ZONING CHANGE REVIEW SHEET

CASE: C814-2024-0001 (500 South Congress PUD) DISTRICT: 9

ZONING FROM: CS-1-NP, CS-1-V-NP TO: PUD-NP

sheet title
proposed
cross sections

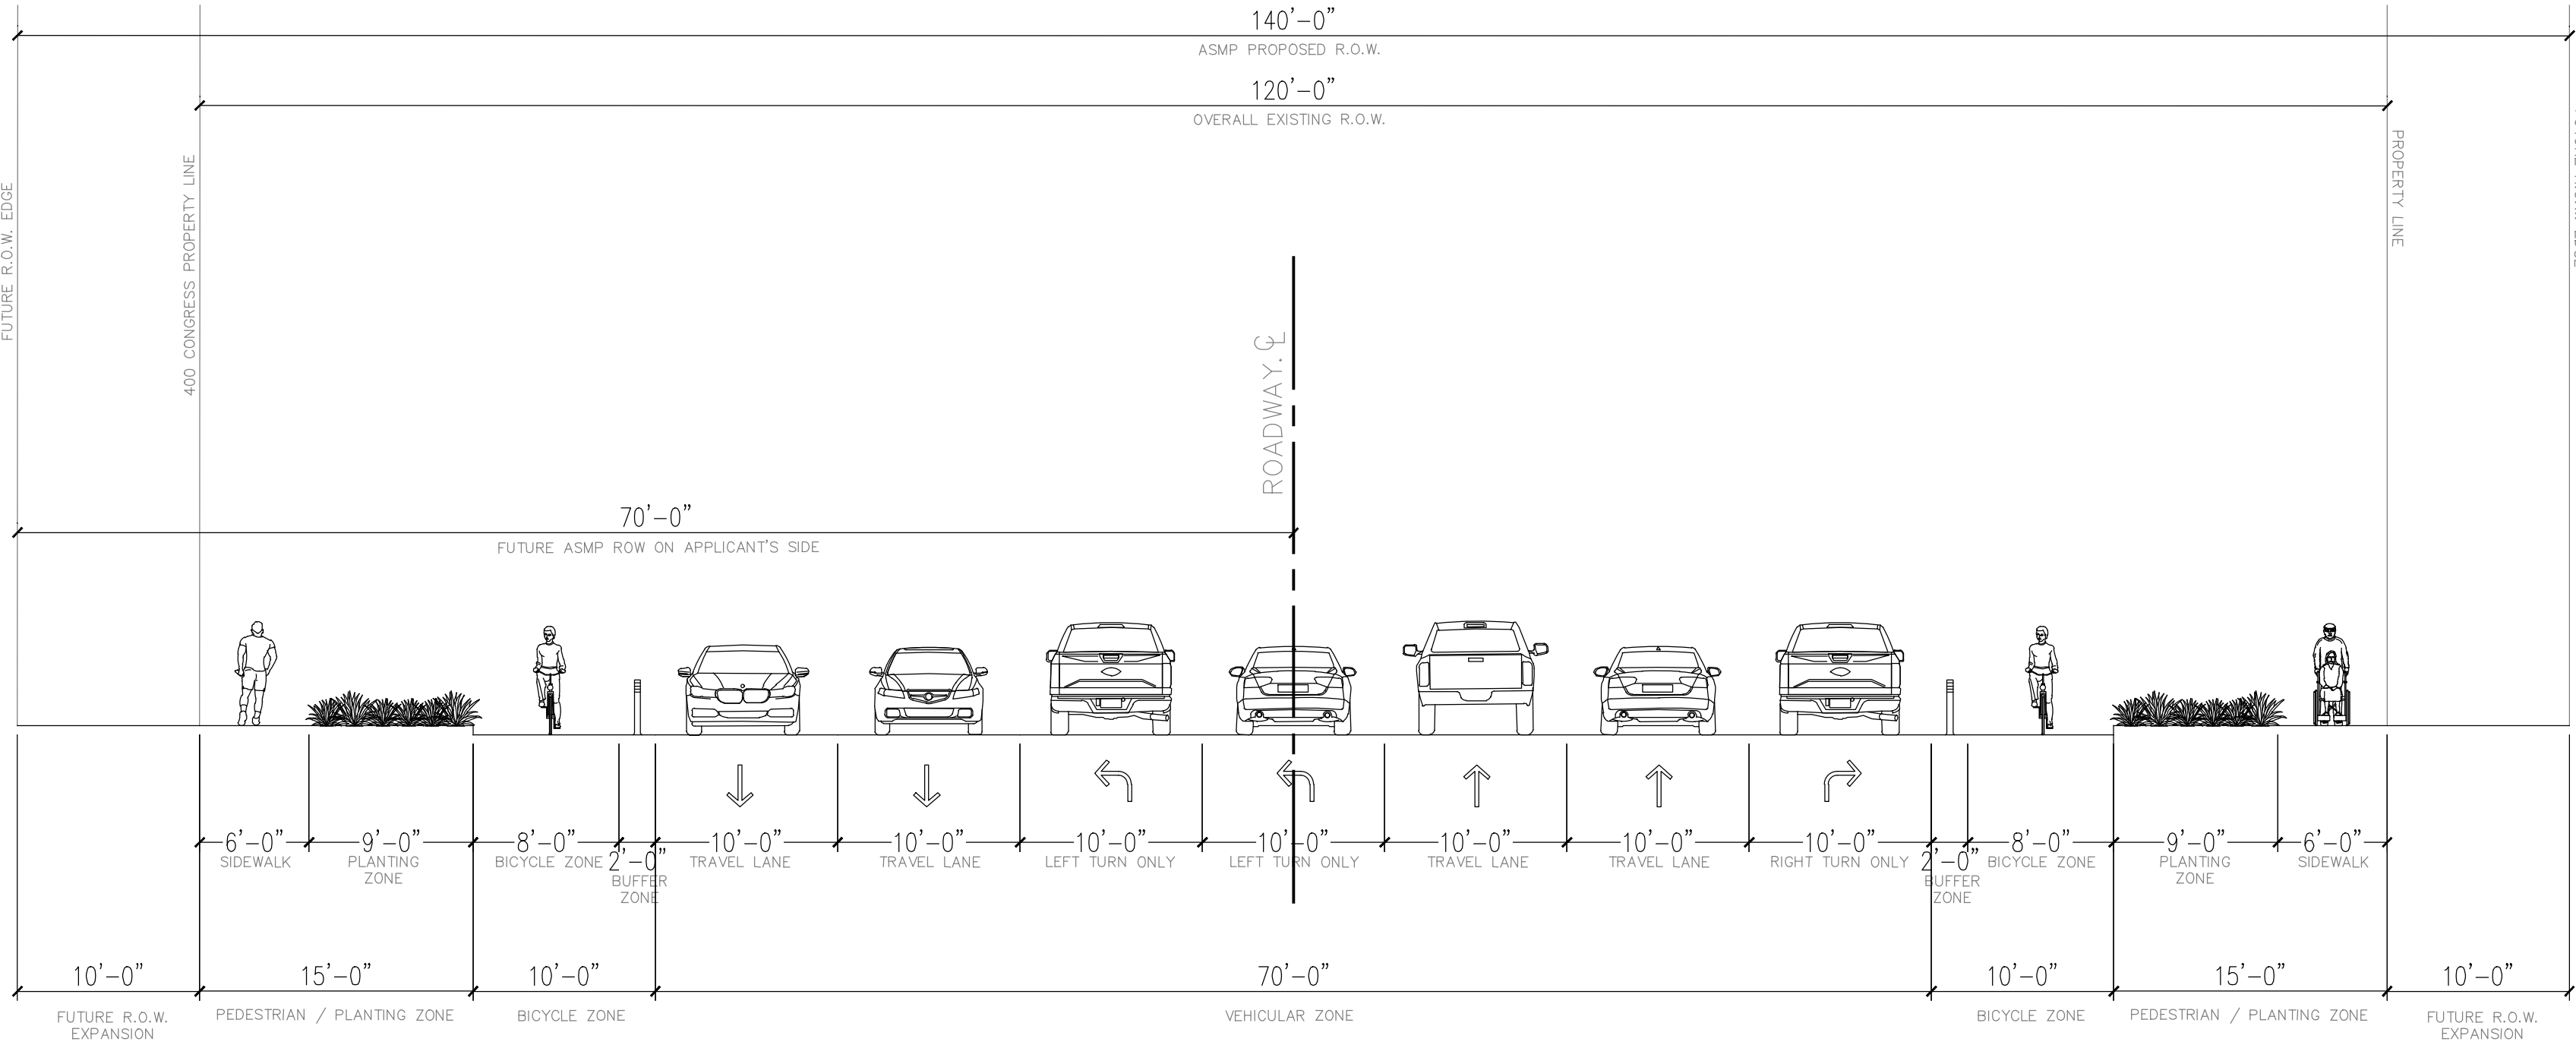
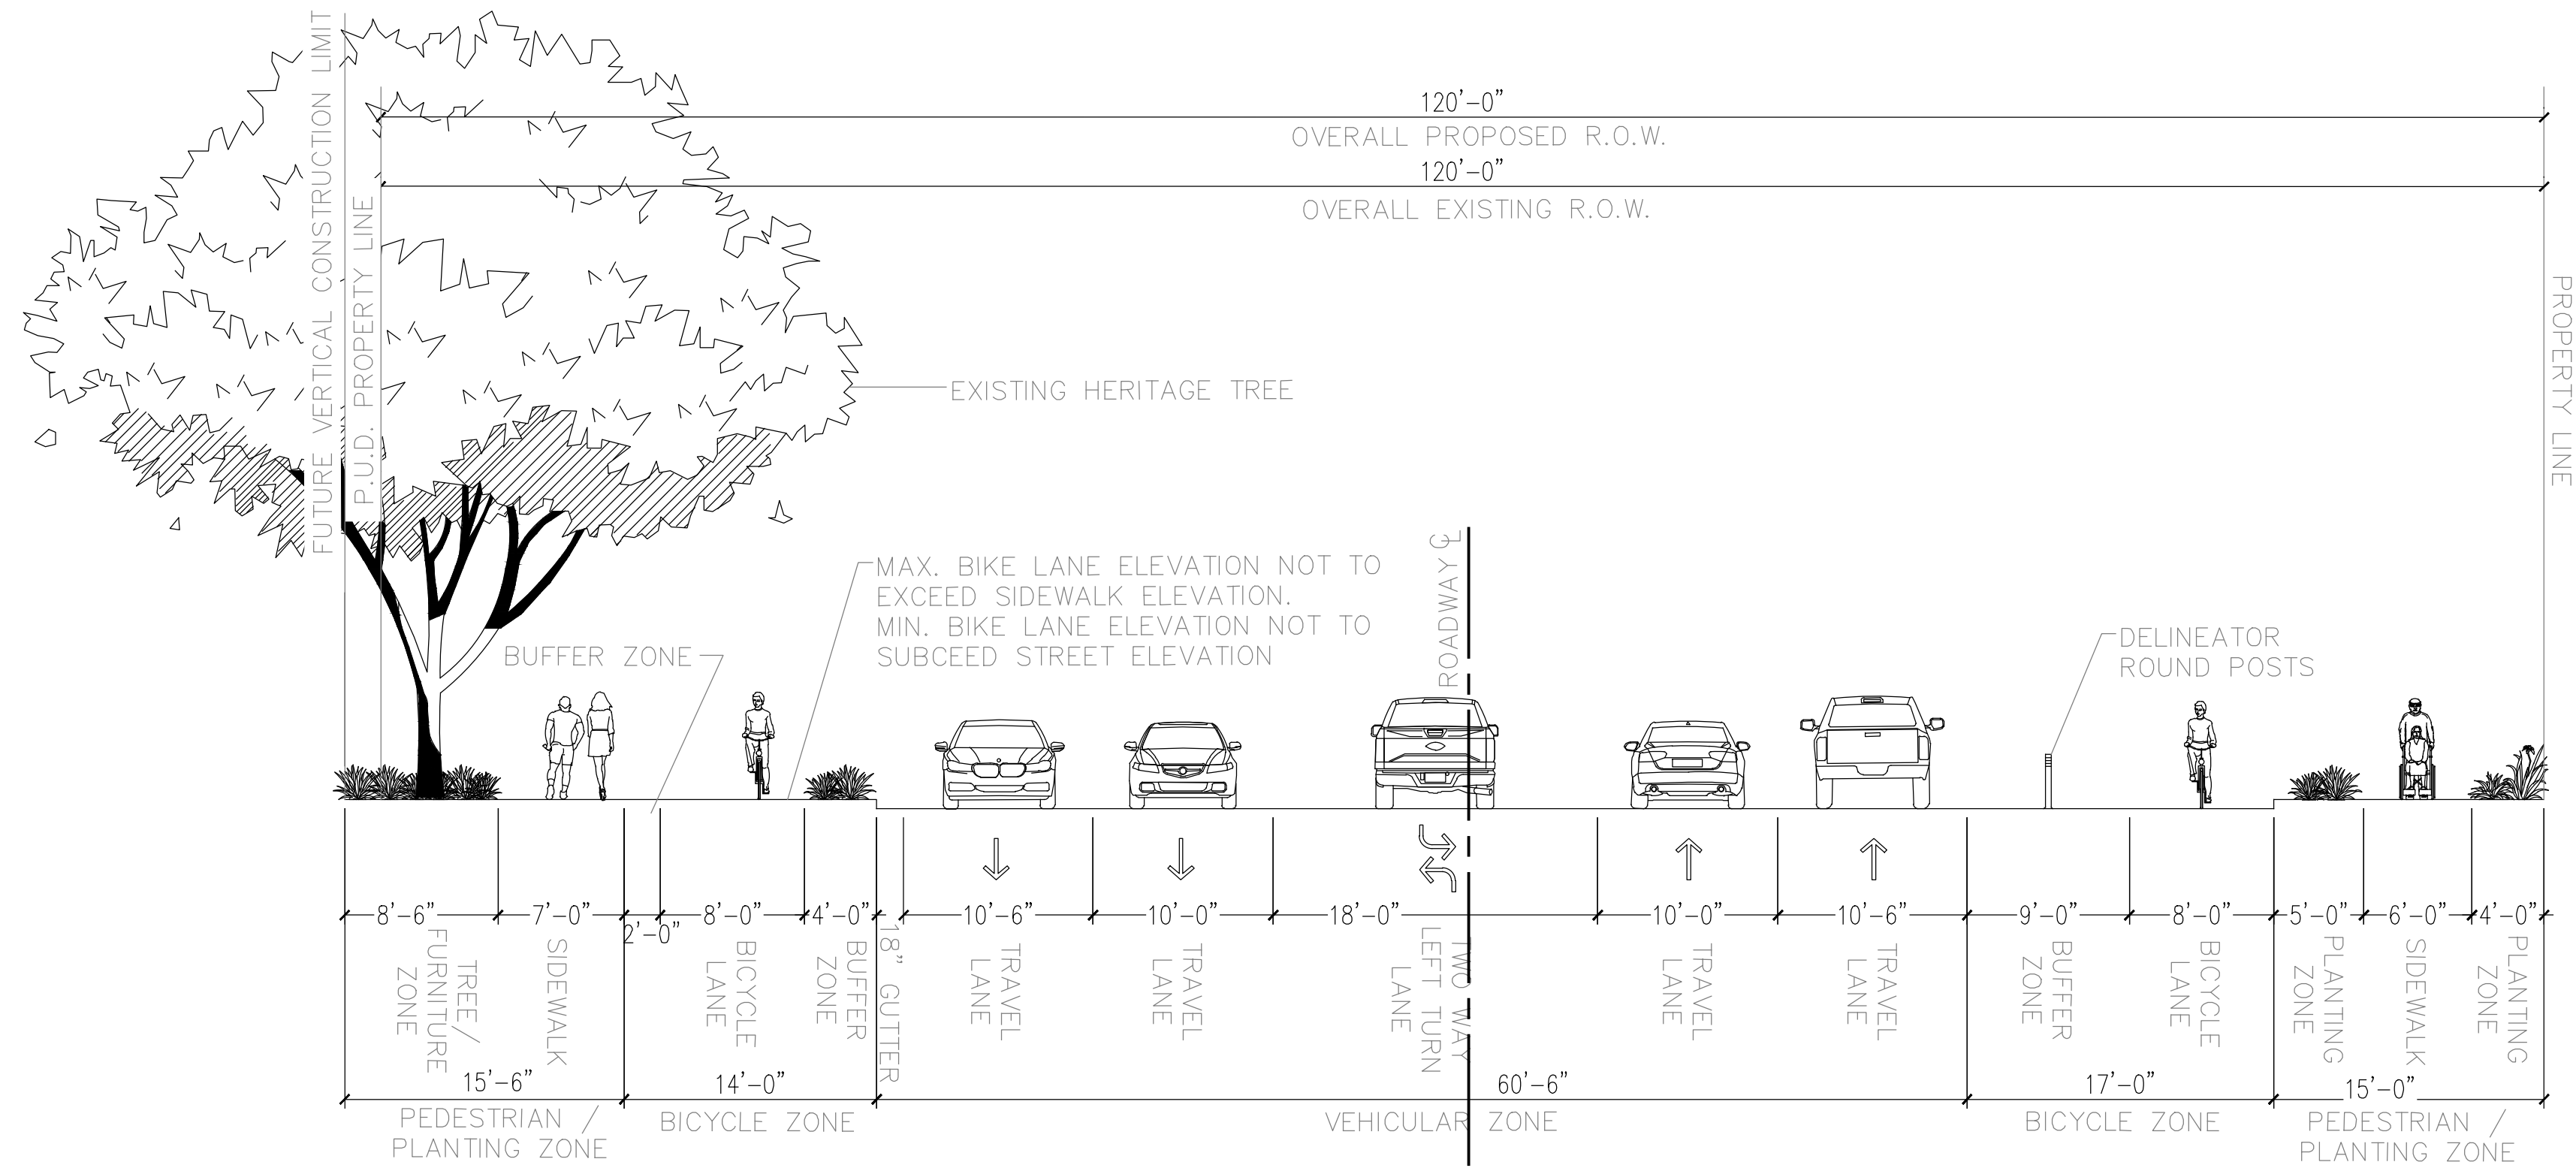
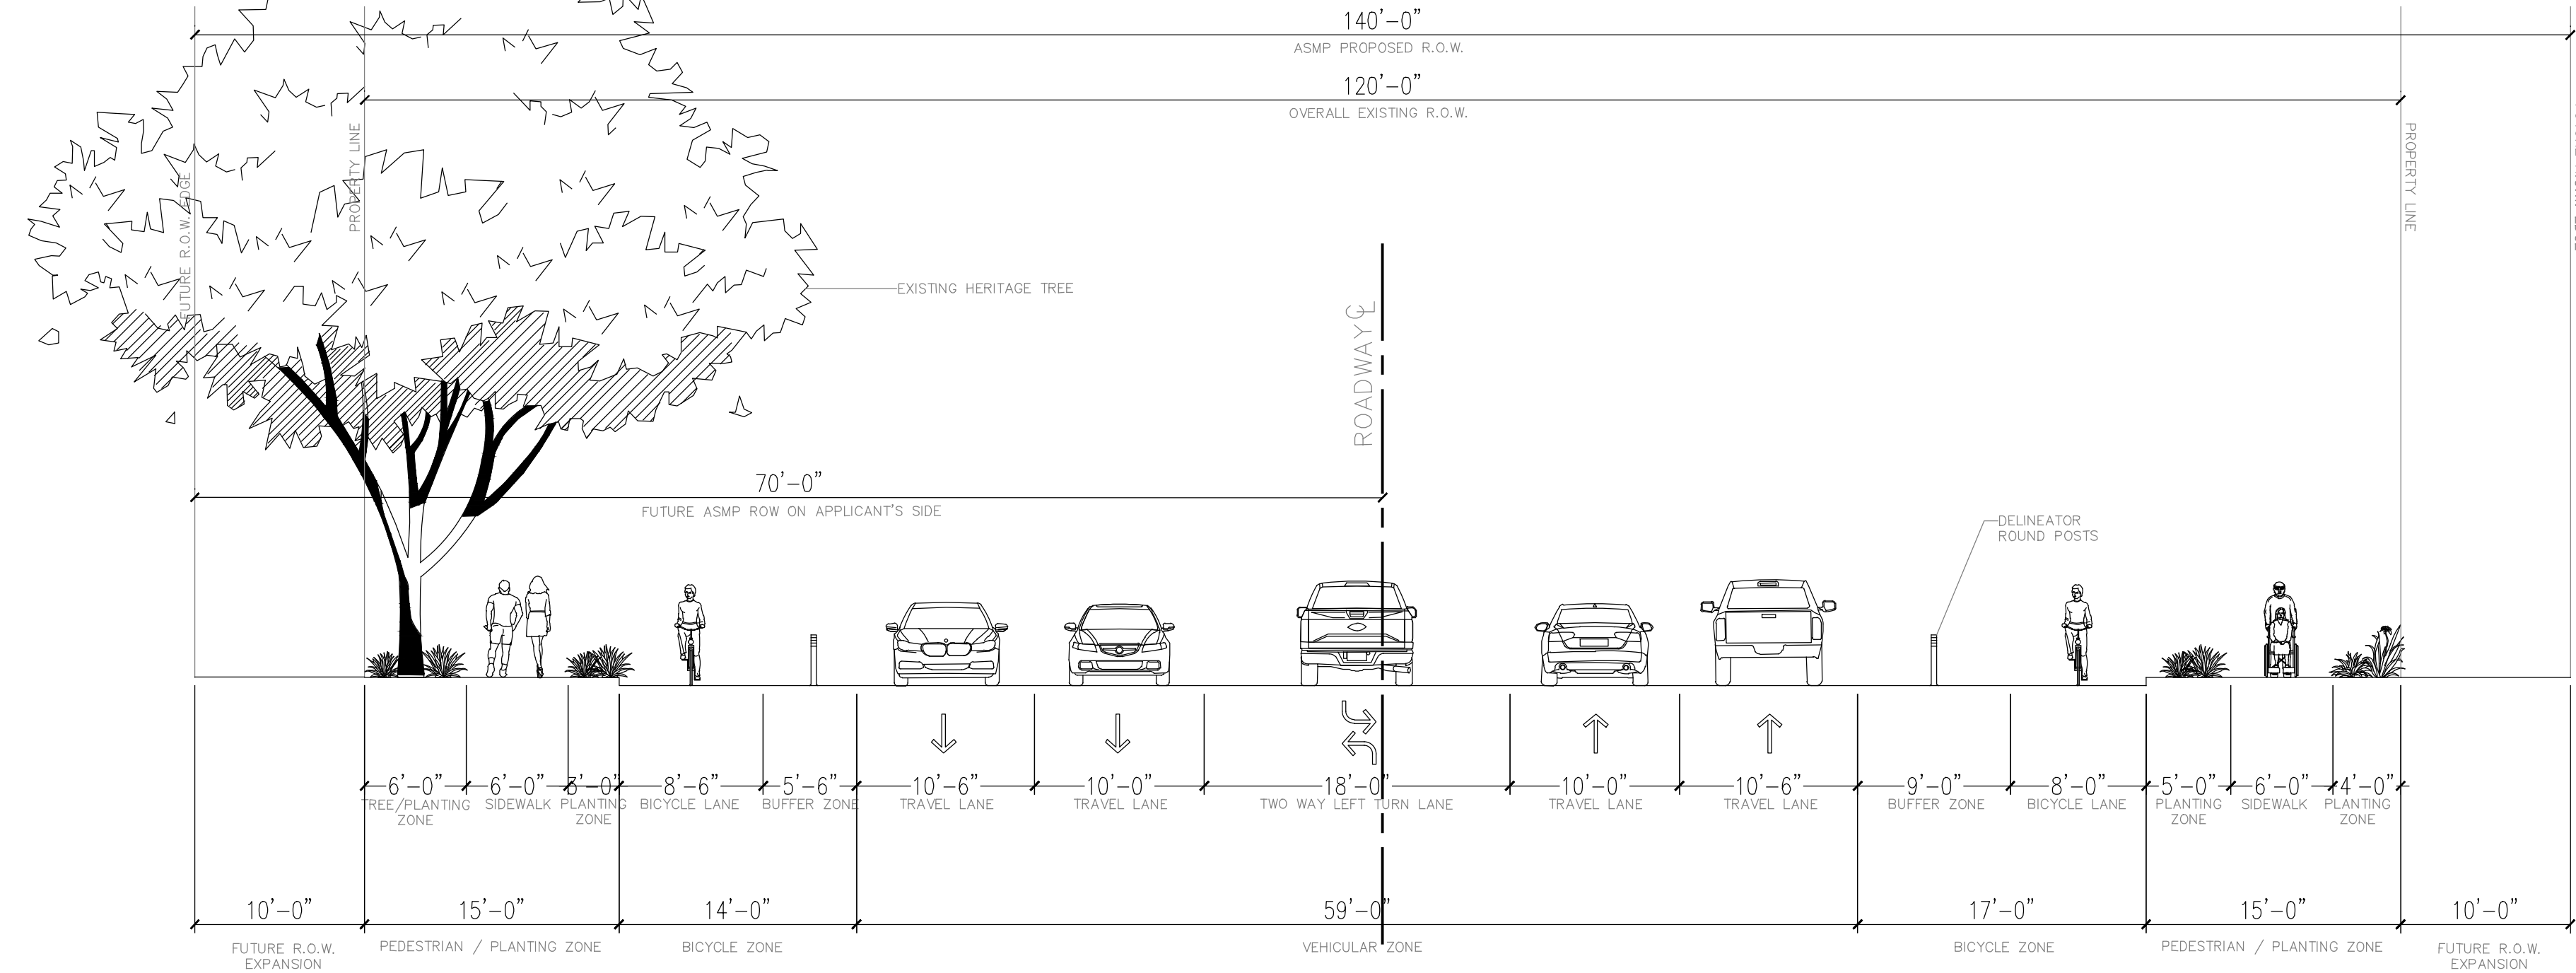
5. Outstanding: "Permanent Access Easement" designation must be added to street cross sections in lieu of "sidewalk easement."
